Customer : CU-DAR001 Dart Helicopters Services	Drawing Name : HELI UTILITY BASKET LH/RH 350/355
Job Number : 36739	
Estimate Number : 10208	
P.O. Number :	Part Number : D350607043
This Issue : 1/14/2008 S.O. No. :	Drawing Number : D350-607 REV F P7-9
Prsht Rev. : NC	Project Number : N/A
First Issue : / / Type : LARGE FAB ASSY	Drawing Revision : F
Previous Run : 36694	Material :
Written By :	Due Date : 2/10/2008 Qty: 1 Um: Each
Checked & Approved By : <u>AS 08 01 15</u>	
Comment : Est Rev:E as Per DS19318 06-01-24 JLM	
Est Rev:F ECN1068 07-12-21 DD

Drawing Name: HELI UTILITY BASKET LH/RH 350/355

DART SERVICE INSTRUCTION

TO AMEND INSTALLATION INSTRUCTIONS D350-607 REV. F

DESIGN <i>CP</i>	DRAWN BY <i>CP</i>	DART AEROSPACE LTD HAWKESBURY, ONTARIO, CANADA	
CHECKED <i>[Signature]</i>	APPROVED <i>[Signature]</i>	DRAWING NO. DSI 9318	REV. A SHEET 1 OF 1
DATE 06.01.06		TITLE WASHER ADDITION	SCALE NTS
A	06.01.06	NEW ISSUE

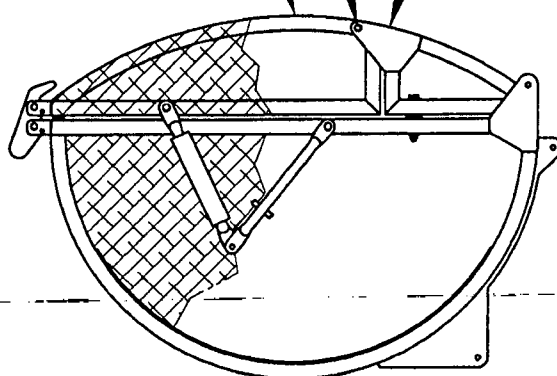
To reduce the possibility of damaging the finish, a **NAS1515H4** washer (2 places) has been added between the hinge plate and basket frame on the **D350-607-043/-047 Heli-Utility-Basket**.

The corrected bolt stackup from Figure 5 of installation instructions D350-607 Rev. F is given below:

AN4-13A BOLT (1)
AN960JD416 WASHER (1)
HINGE PLATE (REF)
NAS1515H4 WASHER (1)
BASKET FRAME (REF)
AN960JD416 WASHER (1)
MS21042L4 NUT (1)
(2 PLACES)
